**Re: 3908 Elbert Avenue - CDSP#2022-00010
Concept #1 | City Compiled Comments**

This letter shall serve as our formal “comment/response” letter for the Concept I Comments dated 04/28/2022 for the above referenced project. The comments and their associated responses are as follows:

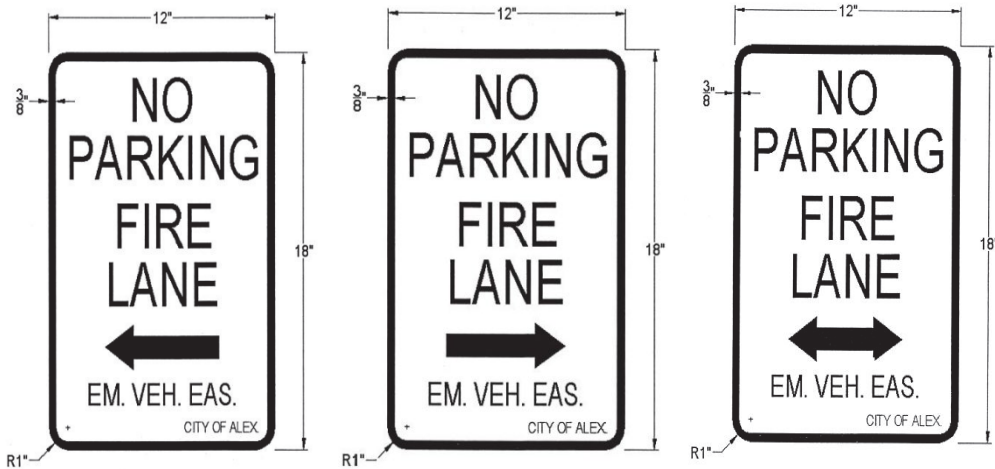
Comment 78: The fire service plan shall show placement of emergency vehicle easement signs. See sign detail and placement requirements are as follows:

- b. Emergency vehicle easement signs shall be metal construction, 12-inches wide and 18 inches in height. Provide red letters on reflective white background with a 3/8-inch red trim strip around the entire outer edge of the sign. The lettering shall say "NO PARKING," "FIRE LANE," "EM. VEH. EAS," and "City of Alex.," Lettering size shall be as follows: "NO PARKING" - 2 inches, "FIRE LANE" - 2½ inches. EM. VEH. EAS. - 1 inch, CITY OF ALEX. - ½ inch. Directional Arrows - 1 inch by 6 inches solid shaft with solid head - 1½ inches wide and 2 inches deep (For examples, see Figures D102.1, D102.2, and D102.3). Signs shall be mounted with the bottom of the sign 7 feet above the roadway and shall be properly attached to a signpost or other approved structure such as designated by the fire official. Posts for signs, when required, shall be metal and securely mounted. Signs shall be parallel to the direction of vehicle travel and posted so the directional arrows clearly show the boundaries and limits of the Emergency Vehicle Easement. In areas where emergency vehicle easements involve two-way traffic, double mounted signs shall be provided. The maximum distance between signs shall be 100 feet. Other special signs or modifications to emergency vehicle easement signs shall be approved by the fire official.

Response: *Acknowledged.*

MODIFIED 3" CURB

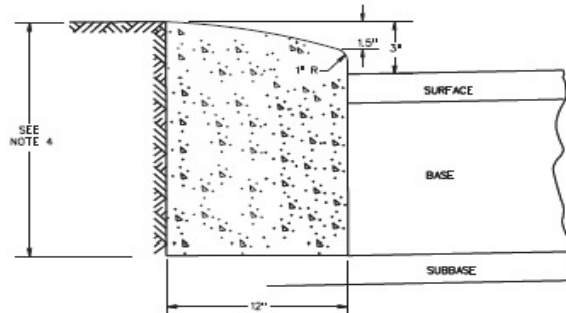
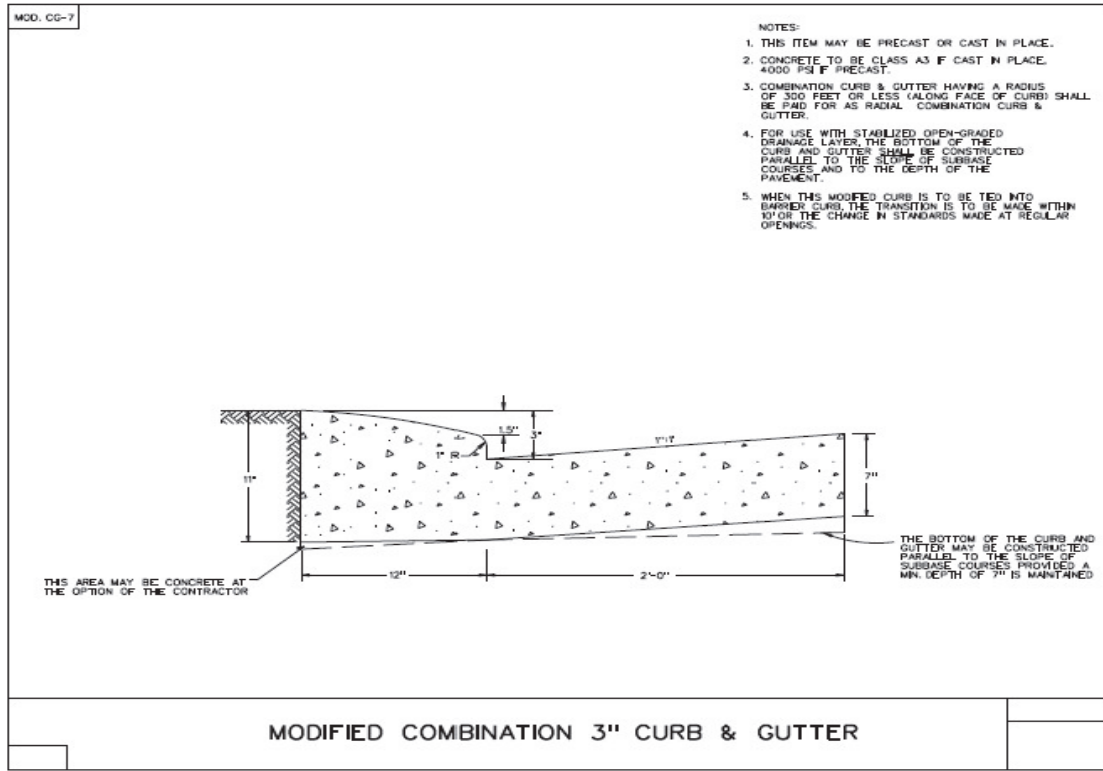
- c. Where curbing is a component of the emergency vehicle easement, the curbing construction shall conform to weight and grade requirements for vehicular traffic. In no circumstances shall a raised curb be in the path of travel in an emergency vehicle easement. Where a mountable curb is provided as part of an emergency vehicle easement, emergency vehicle easement signs shall be posted at the point nearest the edge of the emergency vehicle easement, but in no case within the clear width of the emergency vehicle easement. Except for flush curbs, any fire department access points that require fire apparatus to mount a curb shall conform to the modified 3-inch curb design standard MOD CG-3 or MOD CG-7 design as shown.

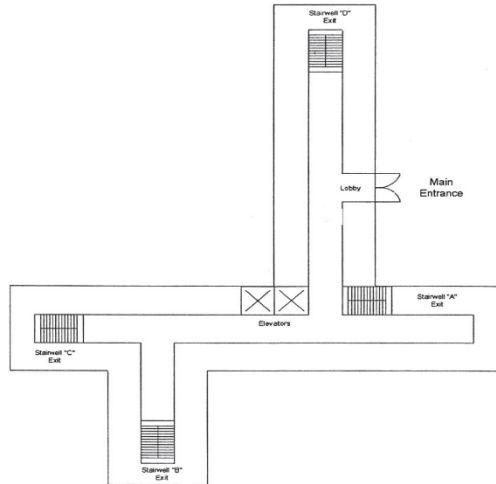
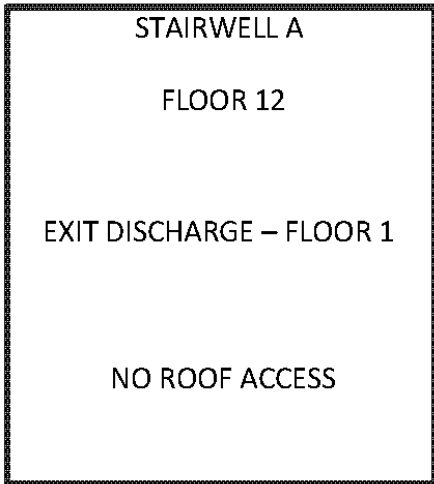
Comment 80: Provide Stairway Identification. Stairway identification signs shall be provided at each landing in all interior exit stairways connecting more than three stories. Stairways shall be identified by letter designation starting next to the main entrance with "A" and continuing in a clockwise or left to right pattern using consecutive letters of the alphabet for each additional stairway. Two copies of the stairway signs shall be submitted to the fire official for approval before occupancy.

Stairway signs shall designate the stairway letter, state the floor level, the level of exit discharge, and if there is access or no access to the roof regardless if the access door or roof hatch locks. The bottom of the sign shall be located five (5) feet above the floor landing in a position that is readily visible when the stairwell door is opened or closed. The signs must have lettering that is a minimum of 2 inches but no greater than 4 inches in height. This information may be stenciled directly onto the wall, but all lettering must be of a color contrasting with the background stairway wall color.

In buildings greater than three stories where there is no graphic representation of the building footprint, a simplified building schematic must be display in the lobby. The simplified building footprint shall be an overhead view of the building exterior and the general layout of the lobby of the first floor. Stairways shall be denoted by letter as required.

Response: *Acknowledged.*
